Reference: H16/0050/94

Description: Internally part illuminated projecting box sign

Location : 3 Market Place Spalding
Lincs

South Holland District Council hereby give notice that CONSENT HAS BEEN GRANTED for the display of advertisements in accordance with the application and plans submitted, subject to the following conditions:

Drawing Title		NON-STANDARD PROTECTIVE SIGN	
Scale	N/A	Date	8-2-94
Drawing No.		1580	
Drawing		Rev B

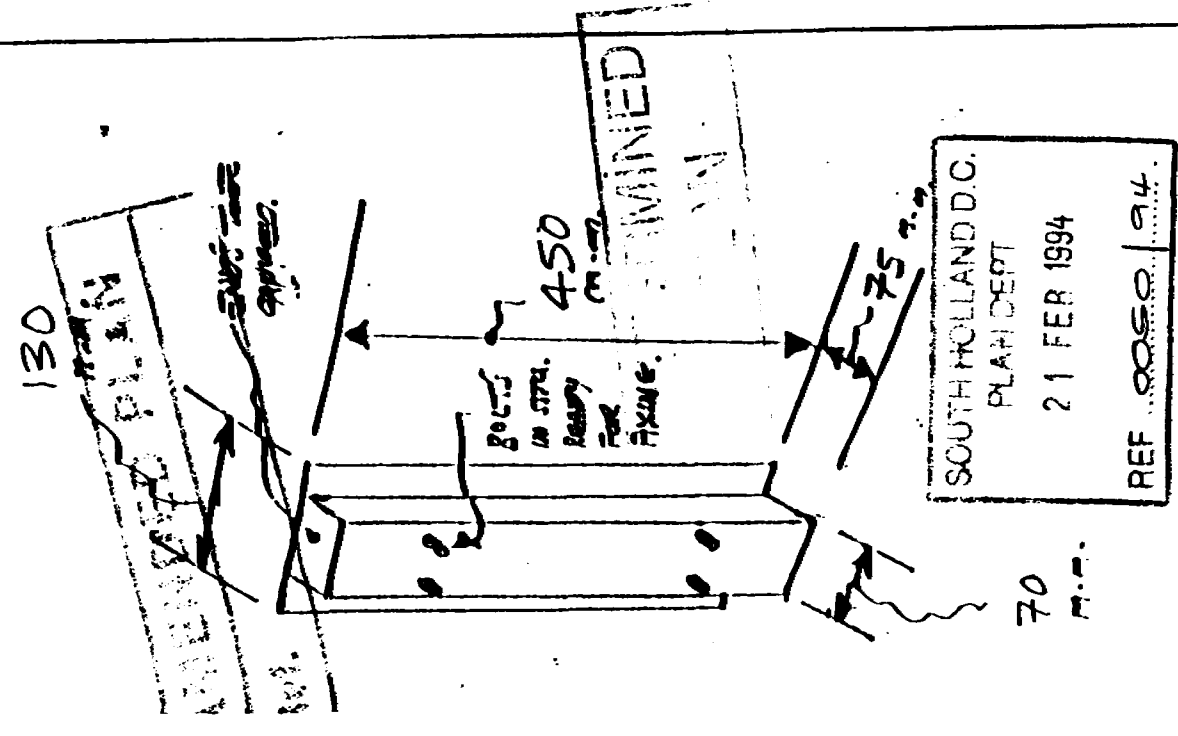
- 2 The proposed projecting box sign shall be fixed to the fascia sign so that its horizontal centre line aligns with the horizontal centre line of the existing fascia sign.

- 3 The brightness of the advertisement hereby granted consent shall not exceed 510 candelas/sq metre.

Having considered the application further I write to request you consider reducing the size of the sign to a depth of approximately 600 mm. The width of the sign may need to be reduced in order to keep proportions. The sign is in the Conservation Area for Spalding and I consider the proposed sign is too large and would detract from the character of the Conservation Area.

REDUCTION IN SIZE OF PROJECTING SIGN

O/A SIGN REDUCED FROM 1060mm x 730mm TO 670mm x 600mm
